**Subject:** Retrofitting a new type of fuel pump according to SOLO Technical Note TM4603-15, instead of the hitherto BING fuel pump

**Applicability:** **ASW 28-18E**, TCDS EASA.A.034, all serial-numbers  
**ASW 27-18E**, TCDS EASA.A.220, all serial-numbers

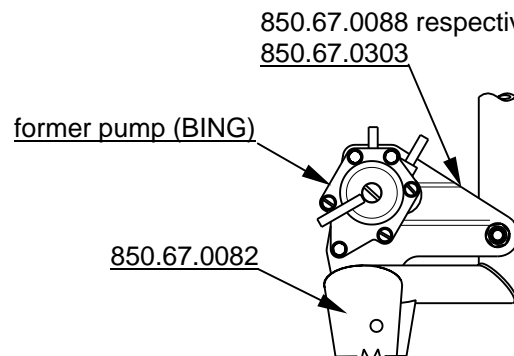
**Reason:** The engine manufacturer SOLO replaces the hitherto pneumatic fuel pump (BING fuel pump, SOLO part number 2300363) through a different type (SOLO part number 2300364), refer to SOLO Technical Note 4603-15. This type requires a different attachment.

**Action:** The BING fuel pump is replaced by the fuel pump, which is described in the SOLO Technical Note 4603-15.

- 1.) Original configuration (two-part engine bearer for „small“ cylinder heads, including left engine bearer 850.67.0082):

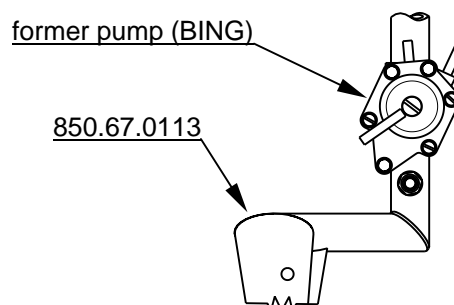
The attachment for the fuel pump (850.67.0088 bzw. 850.67.0303) becomes obsolete.

The new pump is mounted according to drawing 850.67.0112, with the connection components given there.

For action 1) three washers  $\text{Ø}8 \times \text{Ø}16 \times 2$  and three new self locking nuts M8 (2x "Stahl-stop" below and 1x "Poly-stop" top) are necessary, where the part "attachment of the fuel pump" is removed.

- 2.) Configuration according to ASW 28-18E TN 16 respectively ASW 27-18E TN 10 (two-part engine bearer for „small“ cylinder heads, but with left engine bearer 850.67.0113):

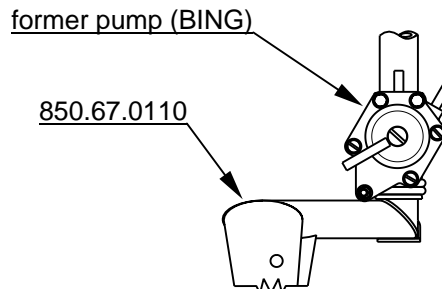
The new pump is mounted according to drawing 850.67.0114, with the connection components given there.
